Town of Arlington, MA Redevelopment Board

Agenda & Meeting Notice August 7, 2017

RE: Design Changes to 483 Summer St Project

**RE: Environmental Design Review & Special Permit Request Relating to
887 Massachusetts Avenue, Arlington, Massachusetts**

Campobasso
Properties, LLC
483 Summer Street
Level 3 Plan
Date 7/31/17
Drawn by CP LLC
Scale 1/4" = 1'-0"
A-3

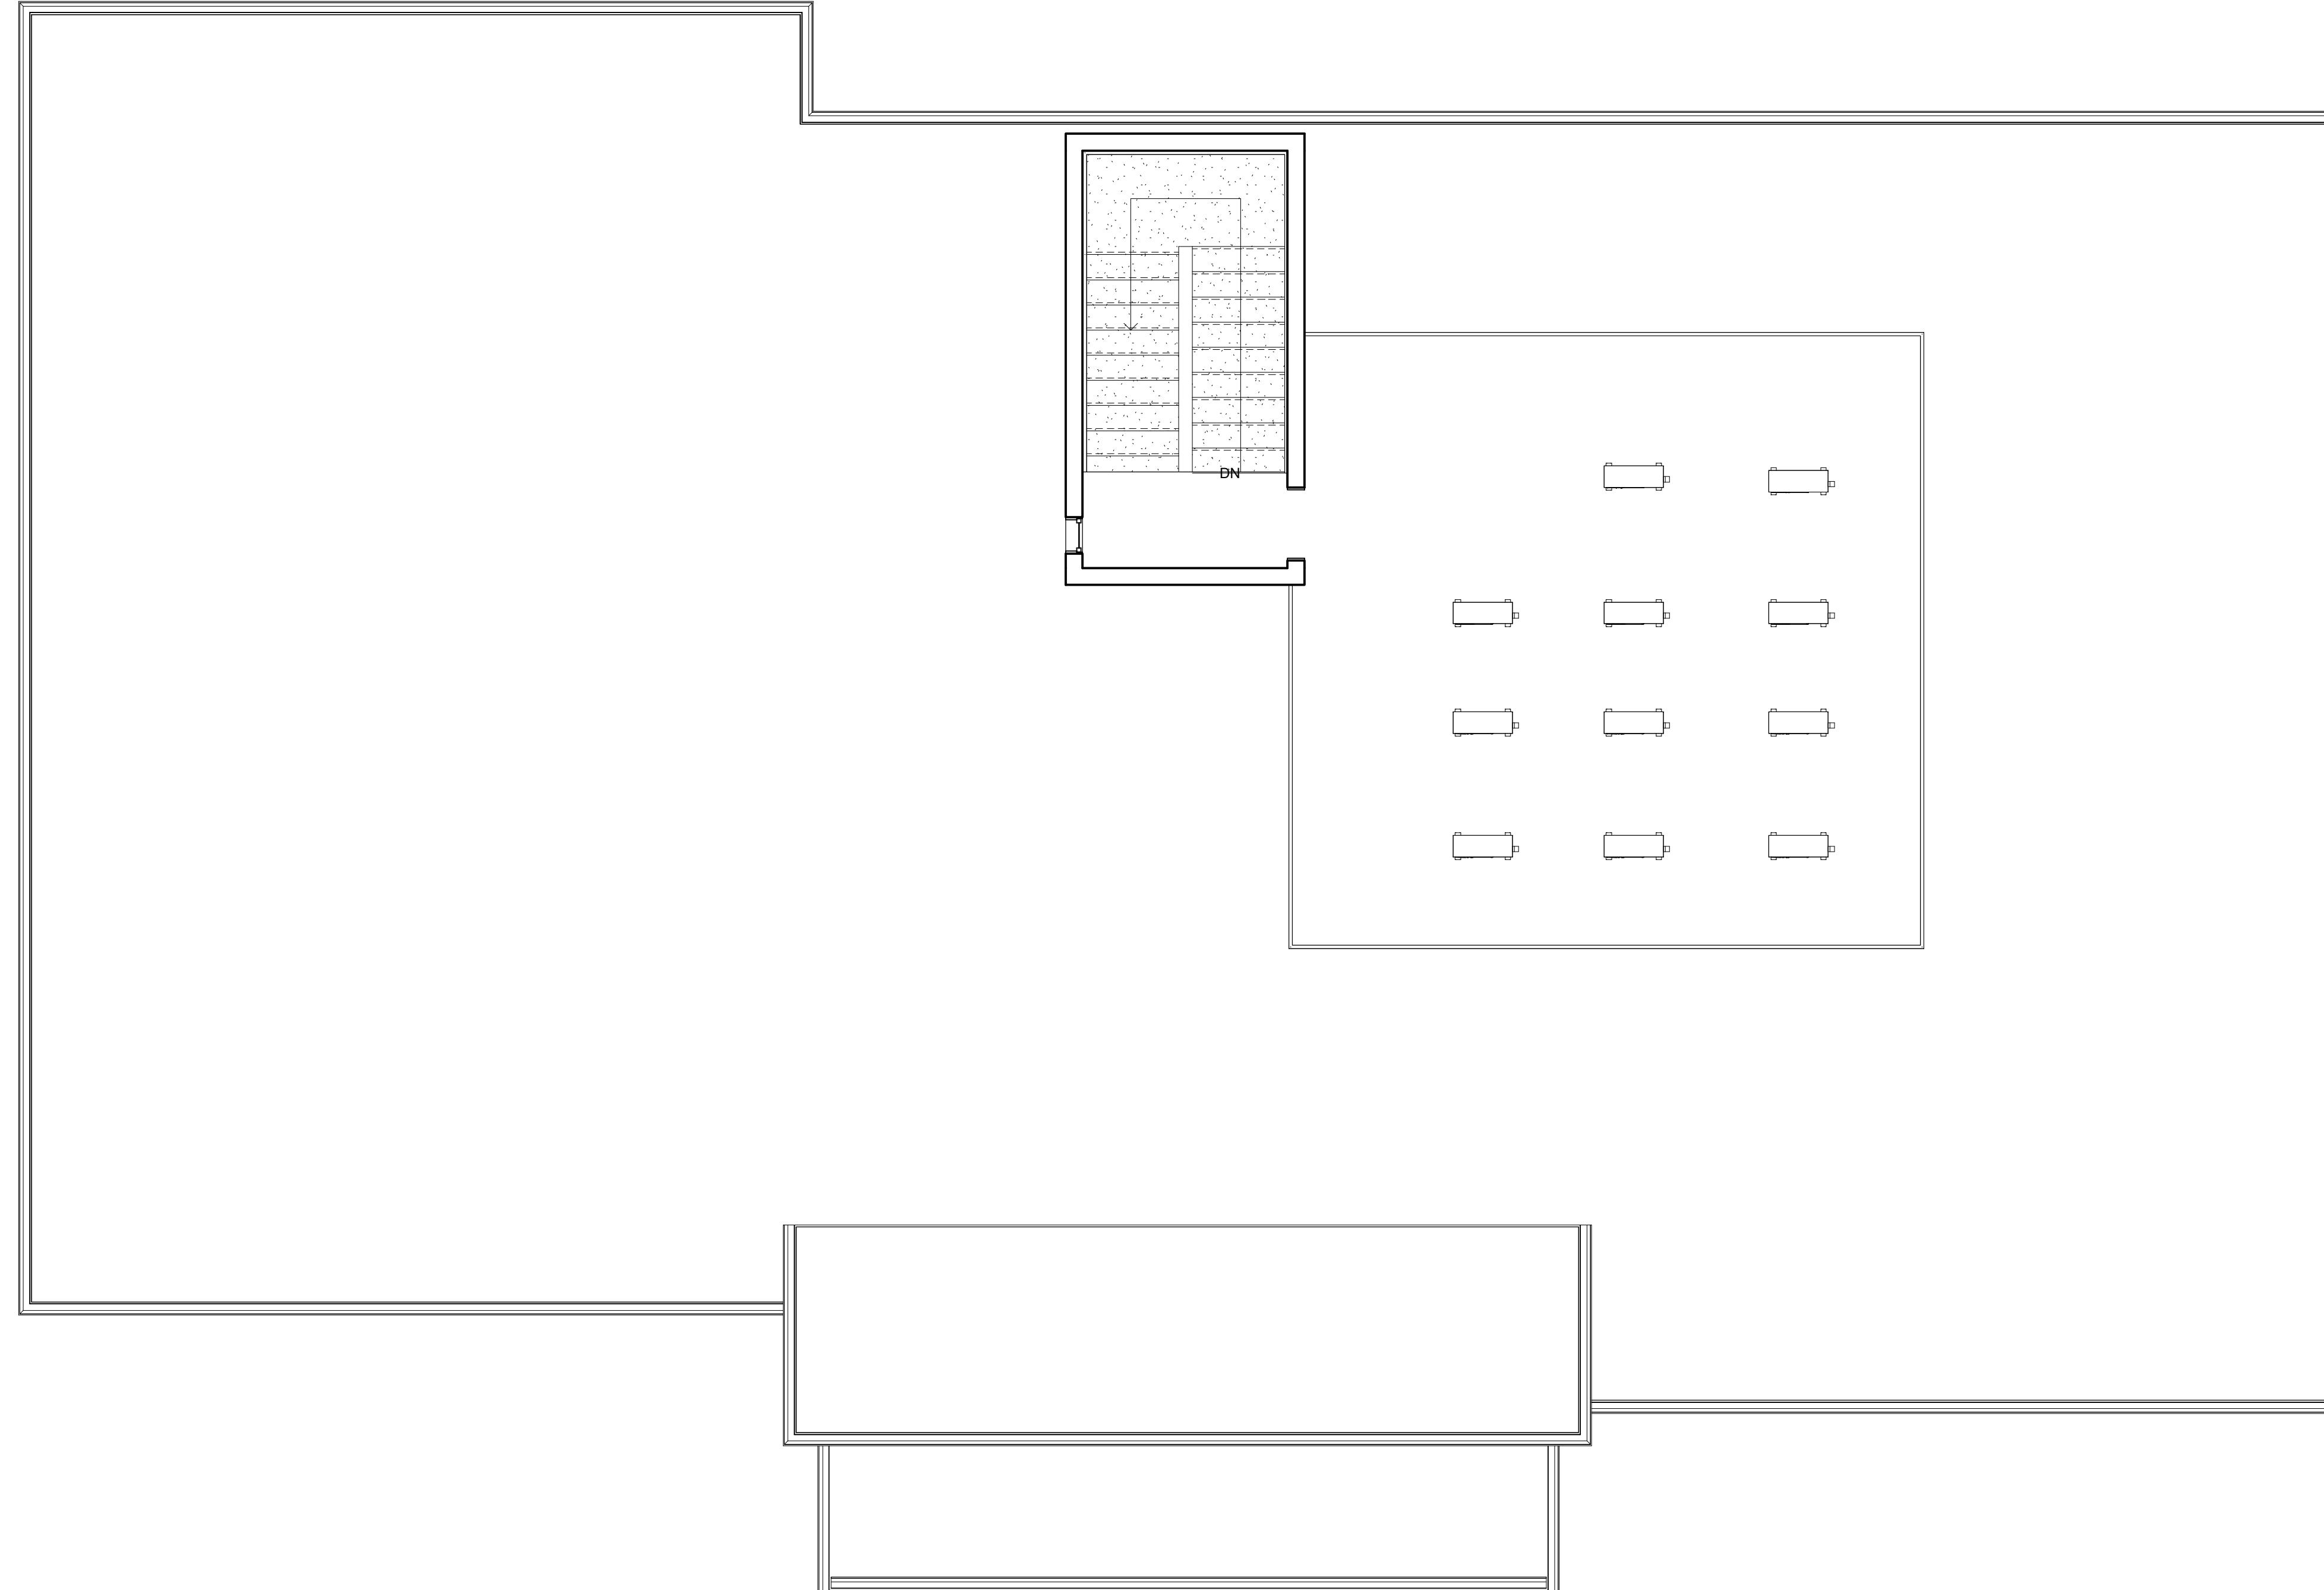
- A-3 – Level 3 Plan: The layout of the apartments will remain ultimately the same with some minor adjustments made for window placements.
- A-4 – Roof Plan: There are two minor adjustments to the roof area. The AC Condensers will be located to the right of the access stair instead of the left side. To enhance the center bay window, we have added a parapet wall towards the front which will be assembled on the roof structure.

Campobasso
Properties, LLC
483 Summer Street
Stair Sections
Date 7/31/17
Drawn by CP LLC
Scale 3/8" = 1'-0"
A-5

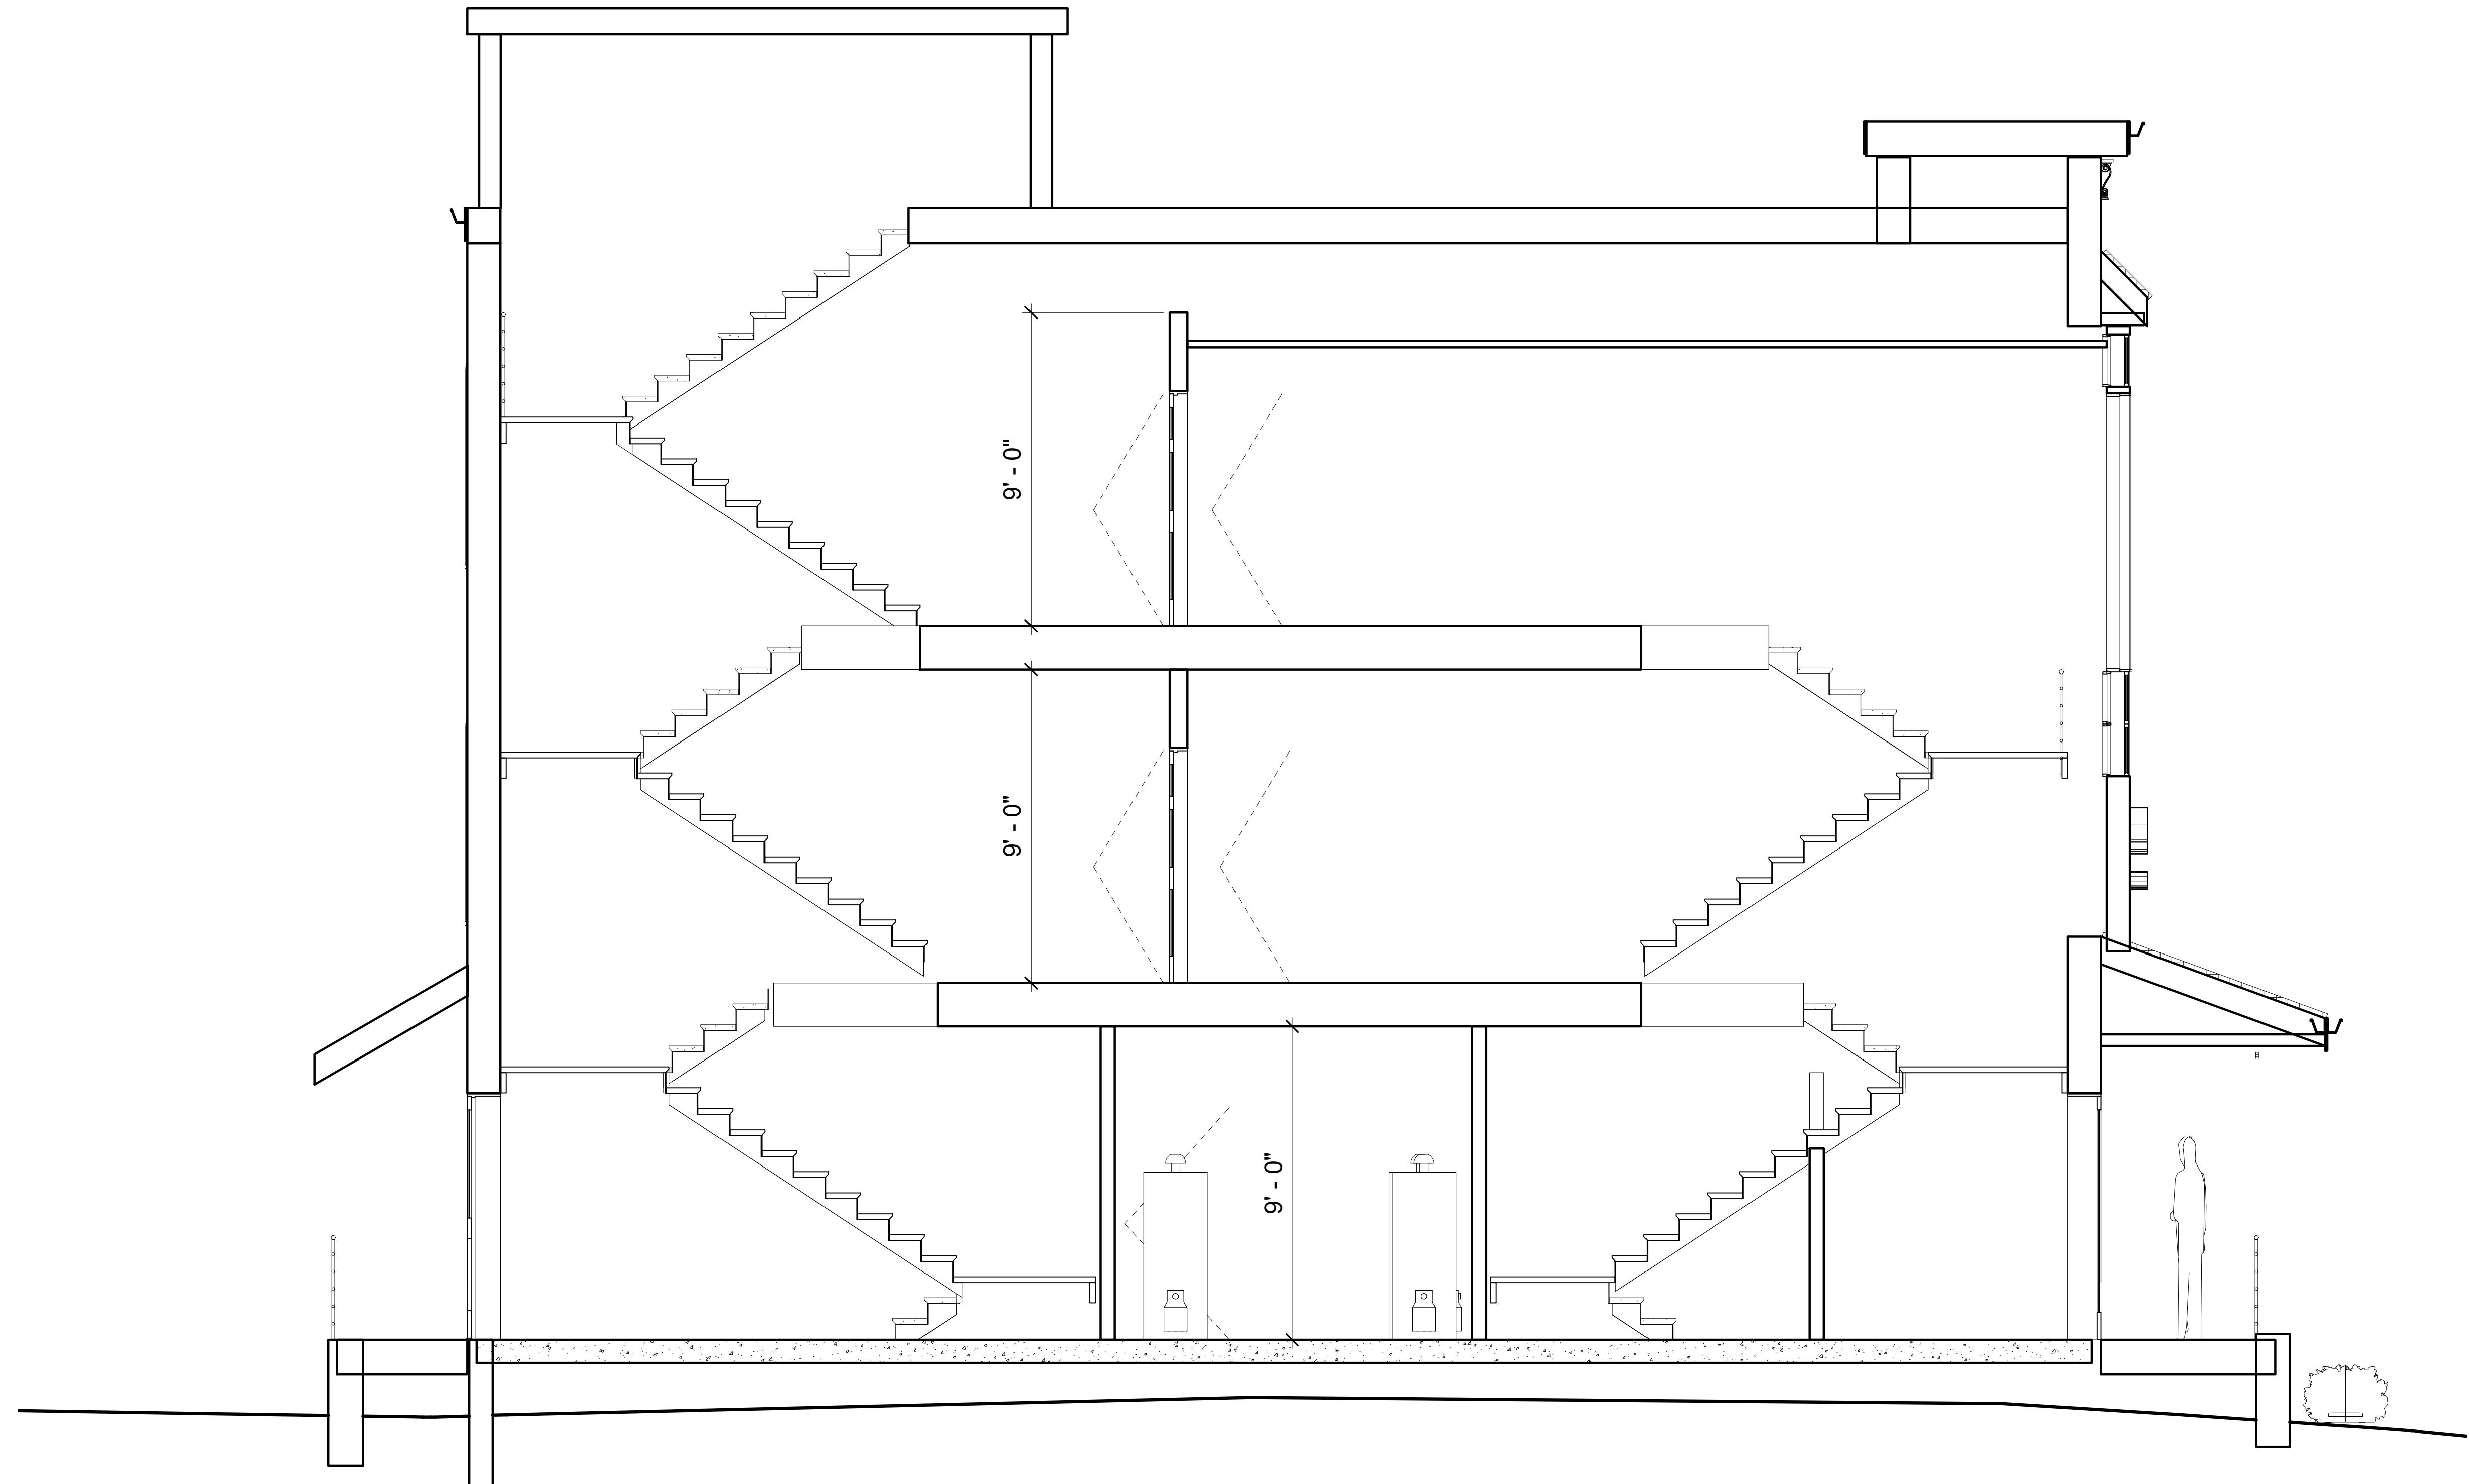
- A-5 – Stair Sections: Minor dimensional adjustments were made from original plan to add headroom and width in the stairway. The ceiling heights have been adjusted to 9'-0" at each level.

PROPOSED SITE PLAN
OF
483 & 489 SUMMER STREET
IN
ARLINGTON, MA

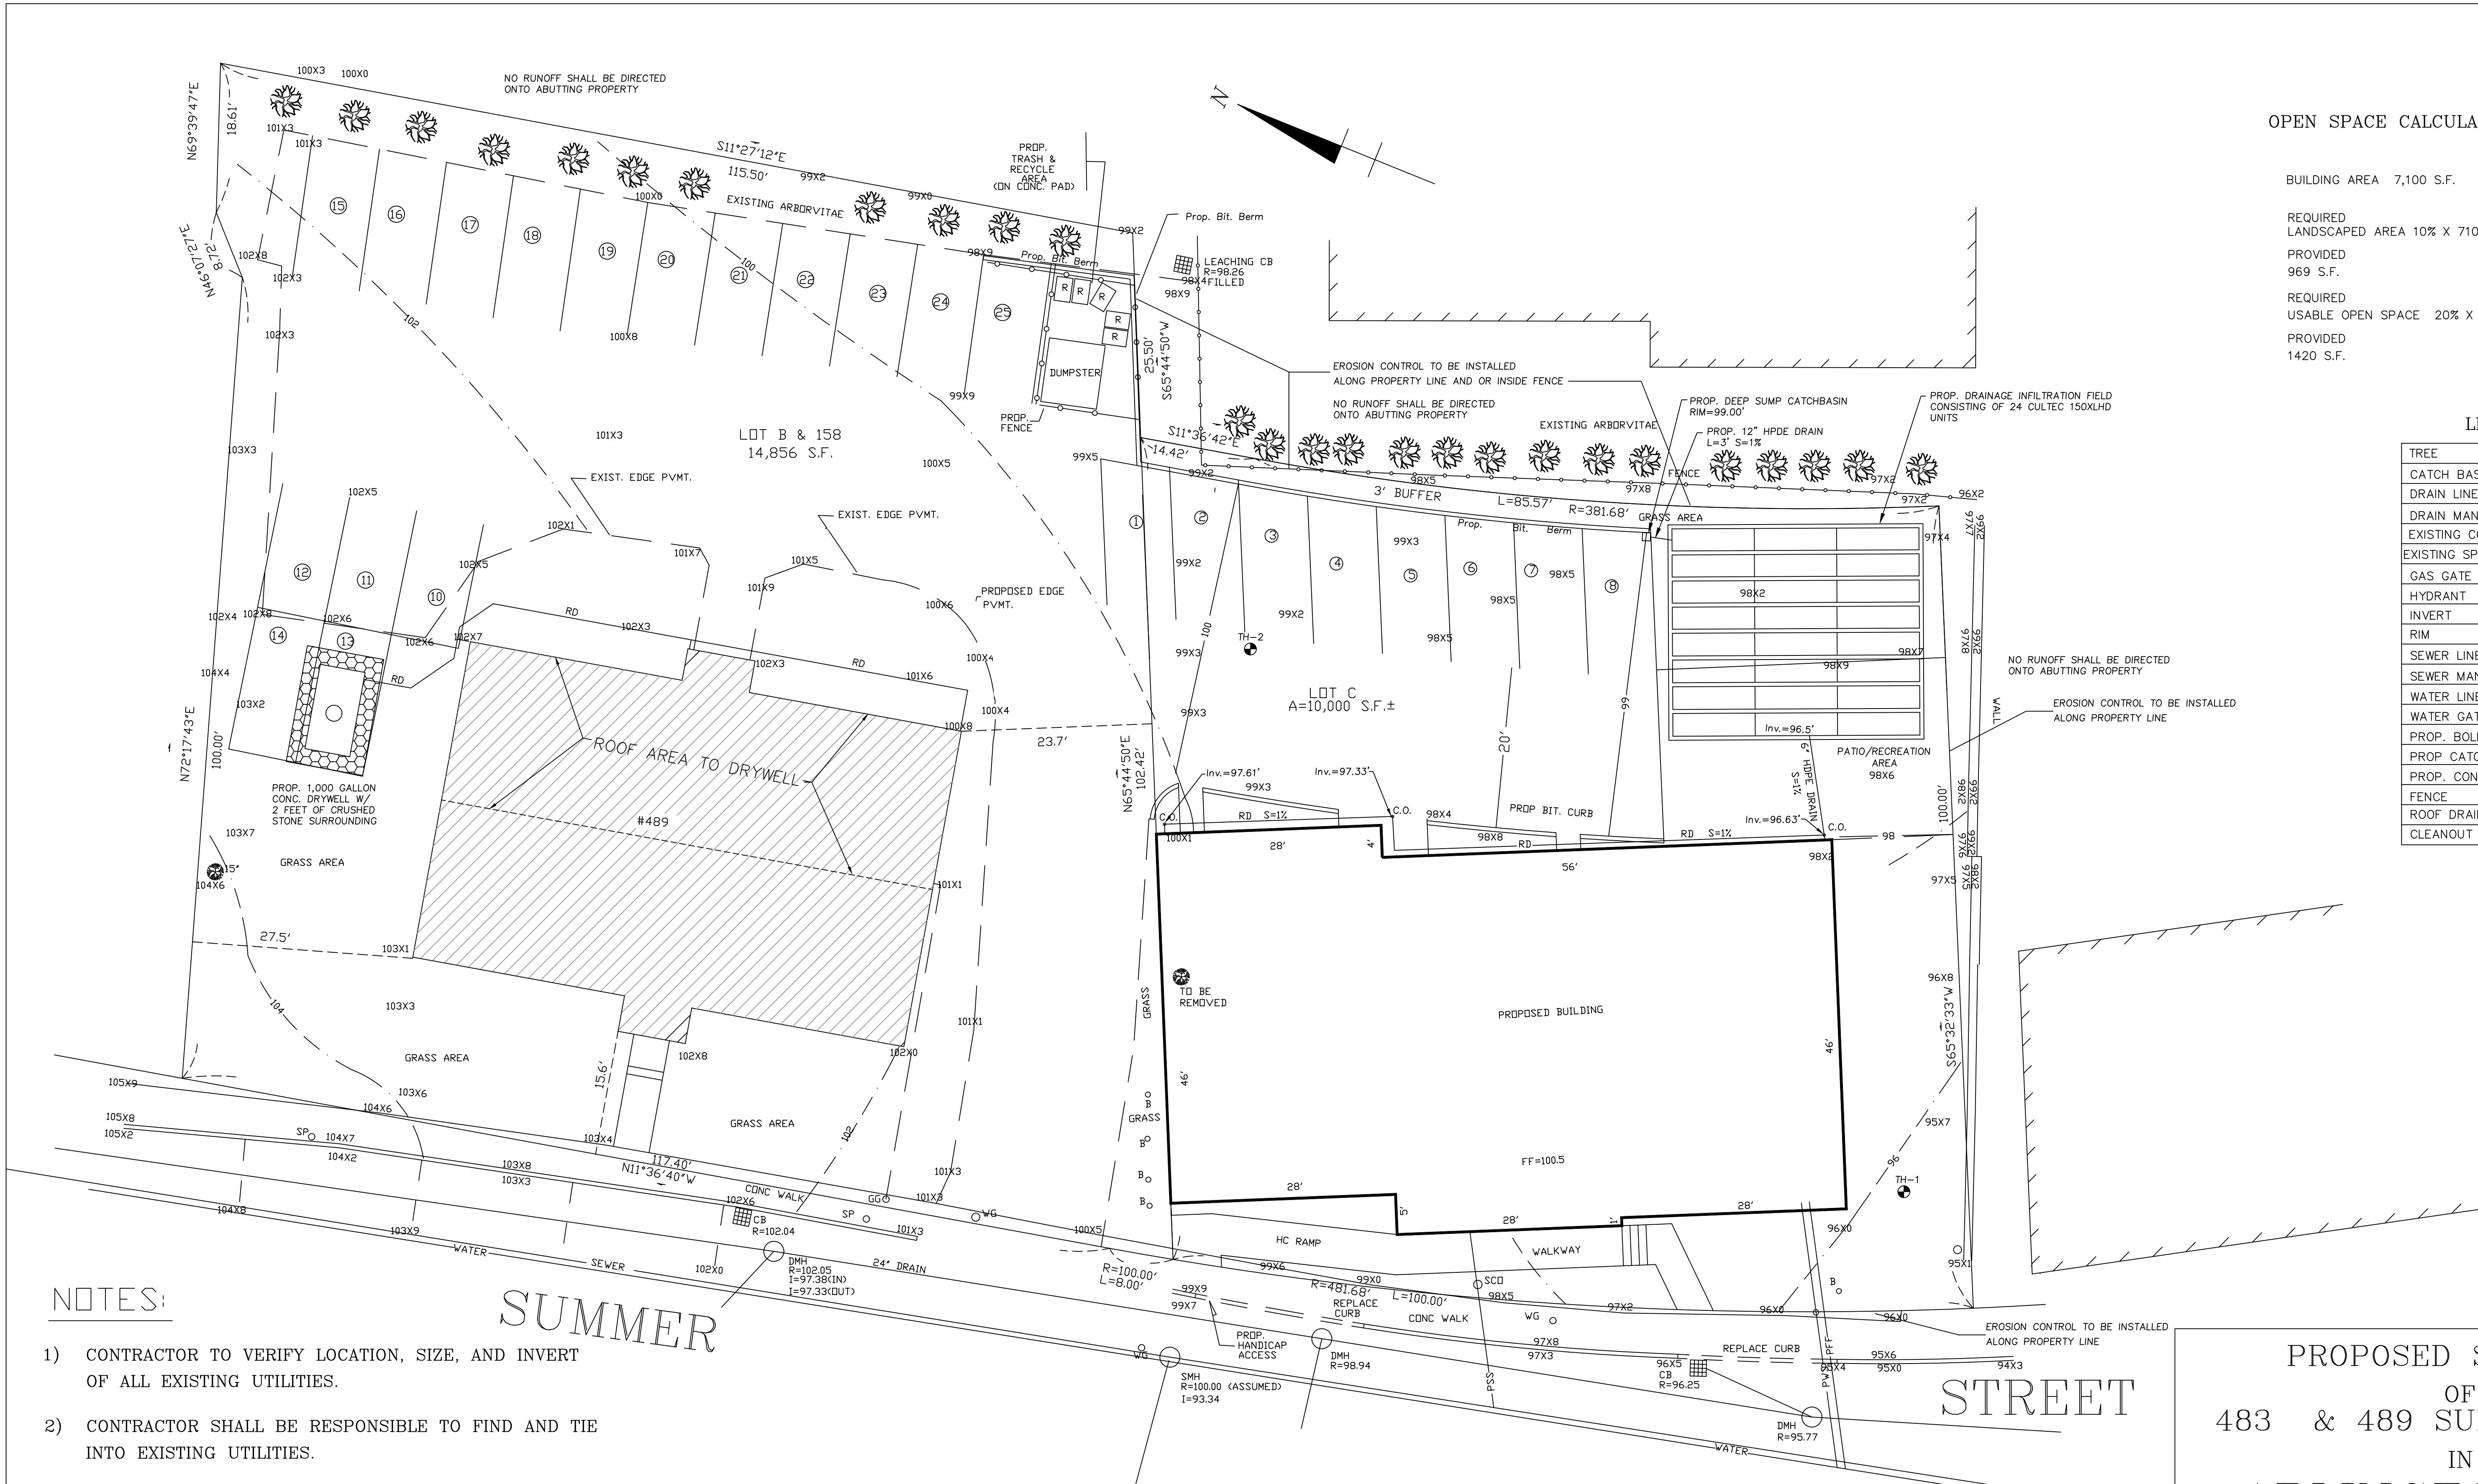
- Civil Plans – No details were changed in the drainage plan. The civil drawing was changed to show (8) parking spaces in the back of 483 Summer Street and (16) spaces in the back of 489 Summer Street. The drawing was adjusted to show the changes made to the front awning but no details were changed for elevation or grade in the front.
